<b>Title - Sujet</b> Snow Removal	
<b>Solicitation No. - N° de l'invitation</b> W0117-171228/A	<b>Amendment No. - N° modif.</b> 001
<b>Client Reference No. - N° de référence du client</b> W0117-171228	<b>Date</b> 2017-11-28
<b>GETS Reference No. - N° de référence de SEAG</b> PW-\$WPG-010-10353	
<b>File No. - N° de dossier</b> WPG-7-40096 (010)	<b>CCC No./N° CCC - FMS No./N° VME</b>
<b>Solicitation Closes - L'invitation prend fin</b> <b>at - à 02:00 PM</b> <b>on - le 2017-12-11</b>	
<b>Time Zone</b> Fuseau horaire Central Standard Time CST	
<b>F.O.B. - F.A.B.</b> <b>Plant-Usine:</b> <input type="checkbox"/> <b>Destination:</b> <input checked="" type="checkbox"/> <b>Other-Autre:</b> <input type="checkbox"/>	
<b>Address Enquiries to: - Adresser toutes questions à:</b> Maki, Christie	<b>Buyer Id - Id de l'acheteur</b> wpg010
<b>Telephone No. - N° de téléphone</b> (204) 891-6126 ( )	<b>FAX No. - N° de FAX</b> (204) 983-7796

This amendment 001 to Solicitation W0117-171228/A is raised to answer questions from the industry.

Diagram 1a

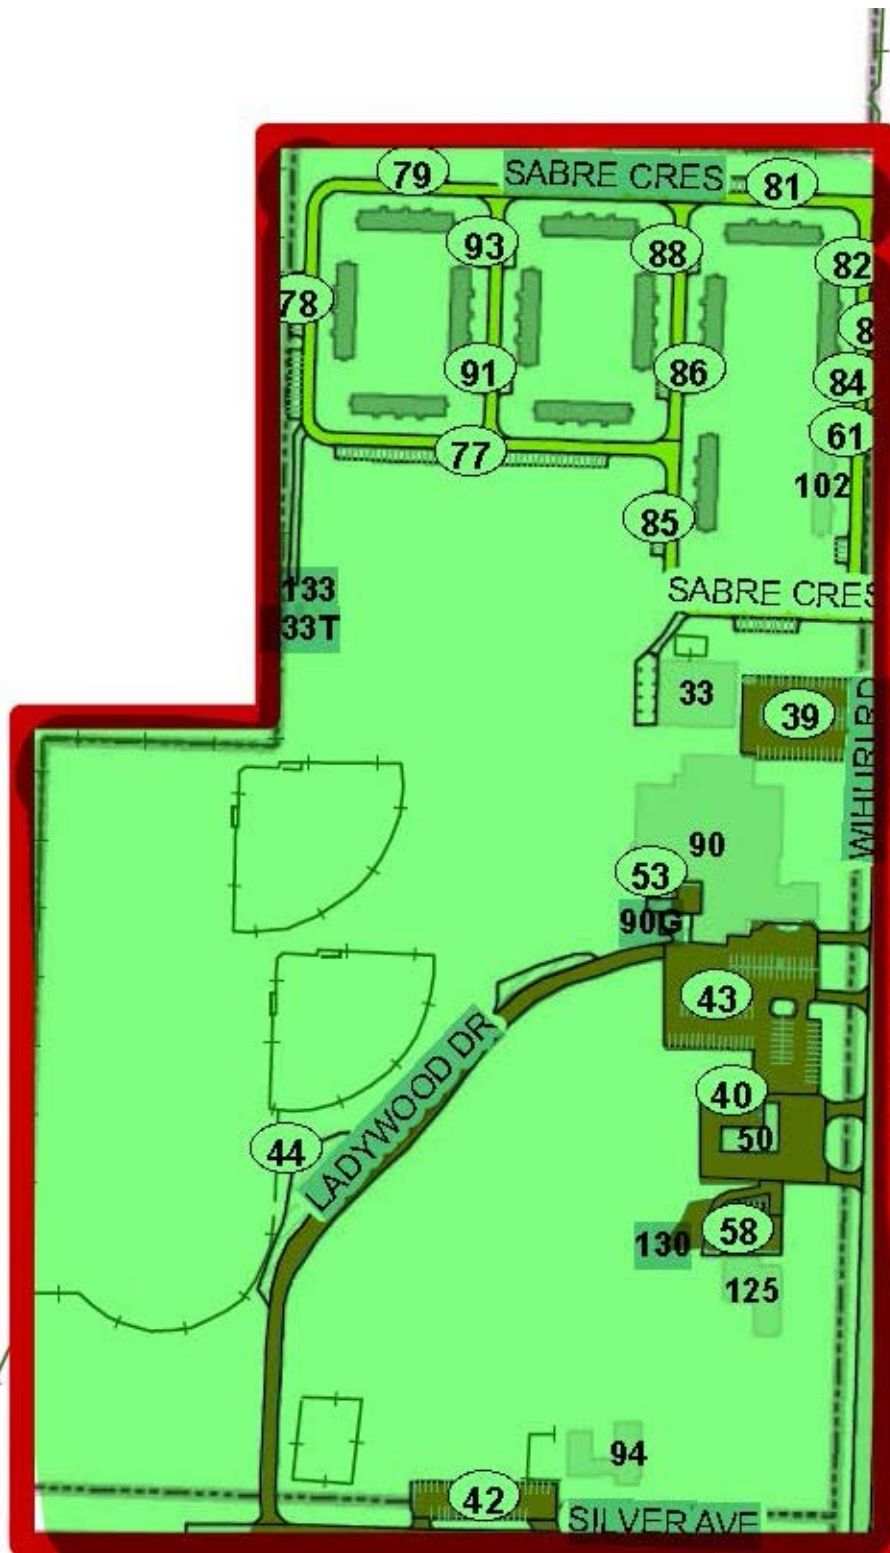
Mc Greggor Armoury SNIC – The shaded area is appx 0.854 hectares, but they are calling for 1.64 hectares. To get this 1.64 hectares, the residential areas should be included. Is the residential area included?

For this portion West of the main gate off of Whytewold/Wihuri, the contractor will be responsible for all of the brown and yellow areas inside of the green box. They are not responsible for Whytewold Ave/Wihuri Rd or the gravel portion of Silver Ave running E/W at the far bottom of the green box as they are a city responsibility.

See Appendix 1, Diagram 1 page 22 of 35

Diagram 1b

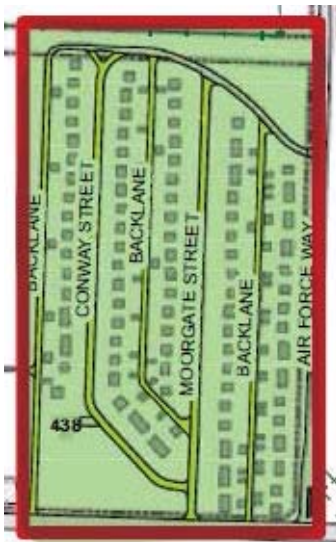
Diagram 1 – base- looking at the area shaded in green, there are area shaded with brown, from my understanding, the brown are the area needs for clearing and the Conway, Moorgate and Airforce way (shaded in green on the right hand side of the drawing).Is that right?

For this portion East of the base off of Ness Ave, the contractor is responsible for the three backlanes, Conway St, Moorgate St, and Silver Ave (unmarked connecting roads to Air Force Way. The contractor is not responsible for Air Force Way or Ness Ave.

See Appendix 1, Diagram 1 page 22 of 35
